MONTGOMERY COUNTY HISTORIC PRESERVATION COMMISSION
STAFF REPORT

| Case Number: | 23/17-17A | Tax Credit: | None |
| Proposal: | Ground Mounted Solar Panel Array Installation | | |

Site Plan

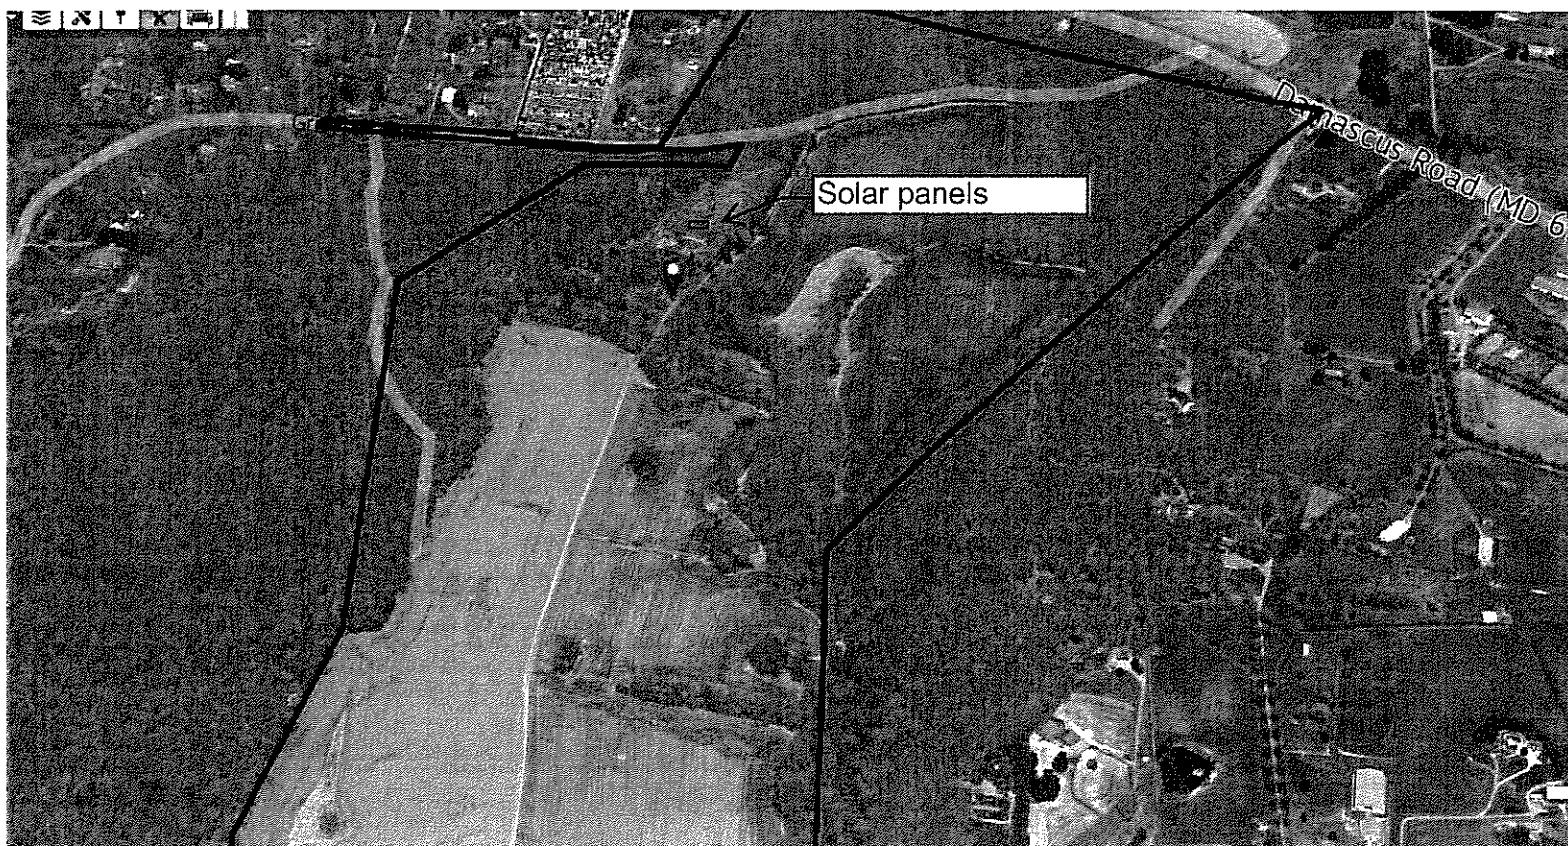
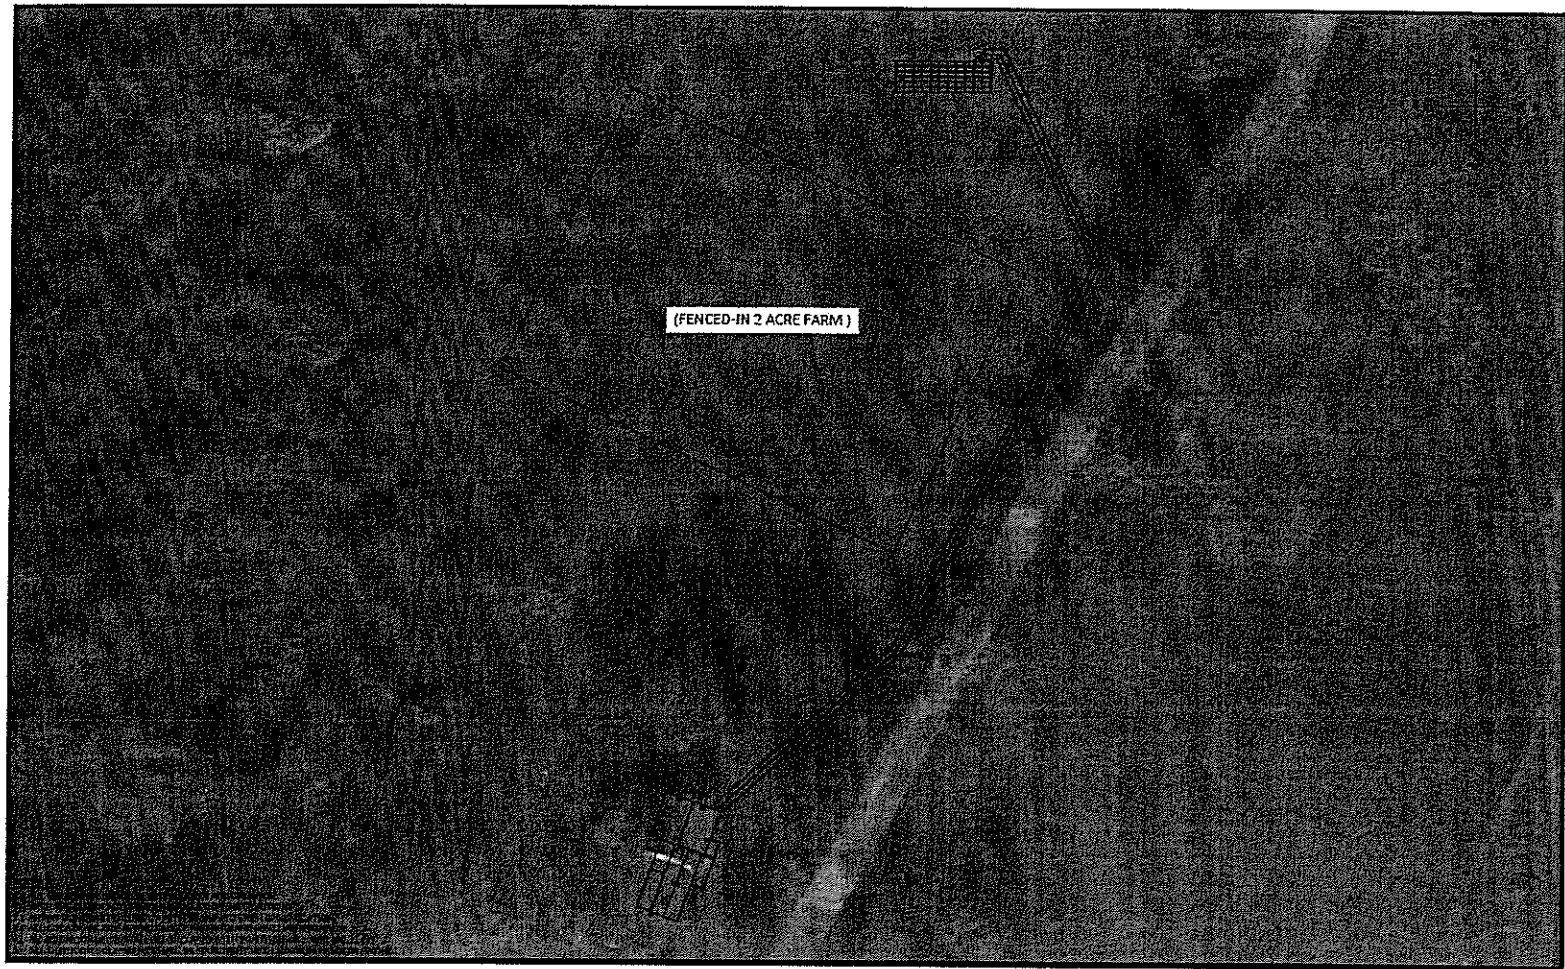
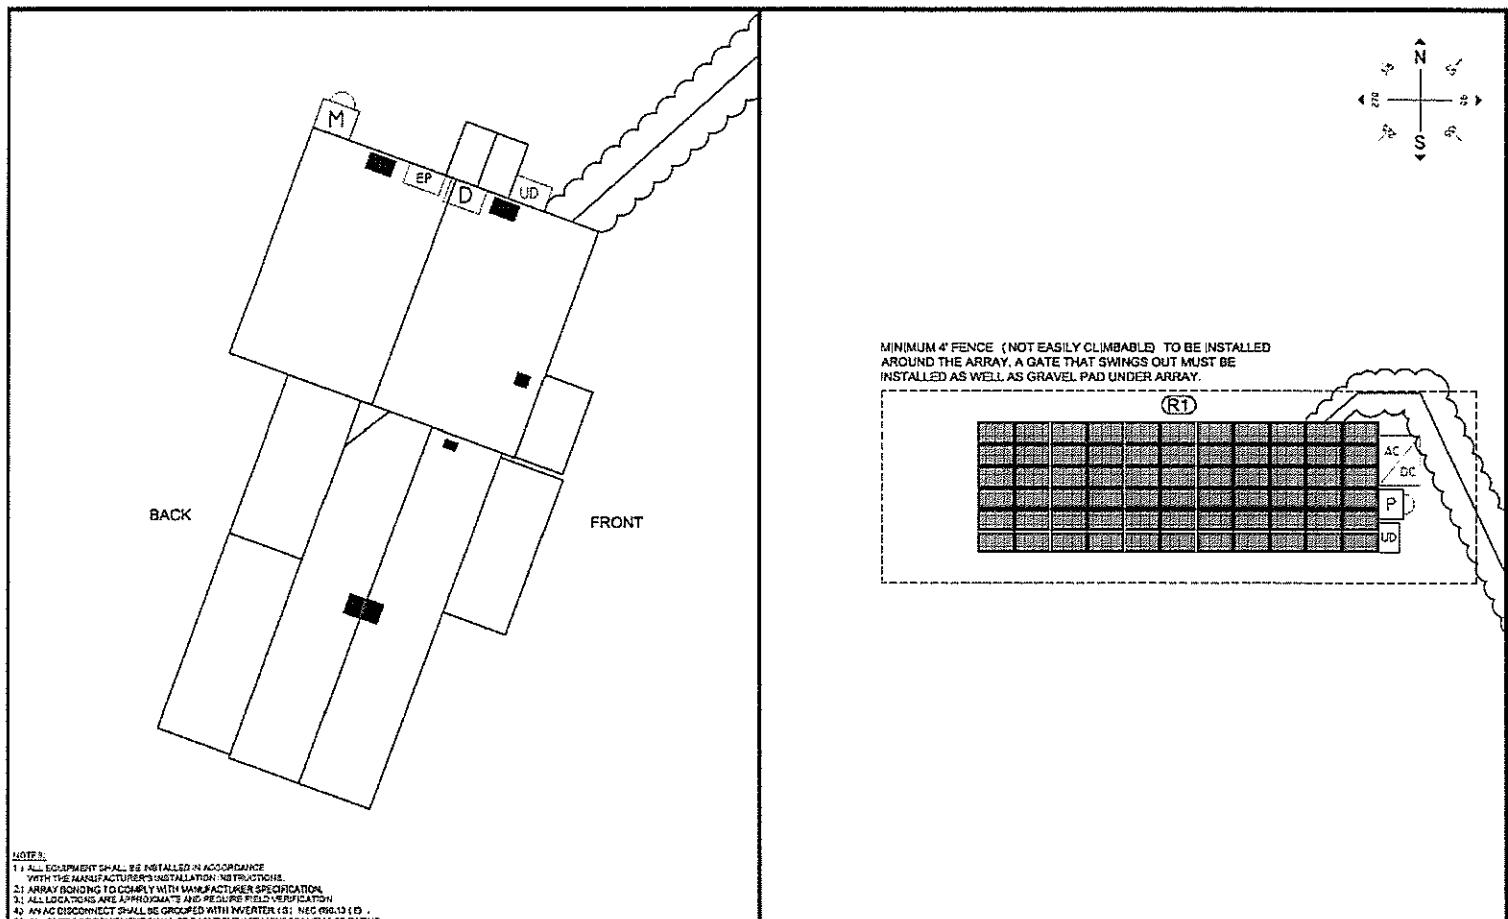
The applicant is proposing to install a 66-panel, ground mounted, solar array several hundred feet from the historic house. The array will be placed to the north of a two-acre fenced-in field and will not be visible from the historic house. The panels will be connected to the house through a buried conduit.

The solar array will not have a significant impact on the historic character of the historic house in compliance with Standard 2. Additionally, the panels will be installed on a framework that could be removed at a future date with no impact on the site, per Standard 10. The design and placement of this array are consistent with the set of best-practices the Historic Preservation Commission has adopted (*Design Guidelines for Historic Sites and Districts in Montgomery County, Maryland, General Rehabilitation Design Guidelines, 9.0 Solar Panels, page 68*). Staff supports this proposal.

Staff recommends that the Commission **approve** the HAWP application; and with the general condition applicable to all Historic Area Work Permits that the **applicant will present 3 permit sets of drawings to HPC staff for review and stamping prior to submission for permits (if applicable)**. After issuance of the Montgomery County Department of Permitting Services (DPS) permit, the applicant will arrange for a field inspection by calling the DPS Field Services Office at 240-777-6370 prior to commencement of work and not more than two weeks following completion of work.
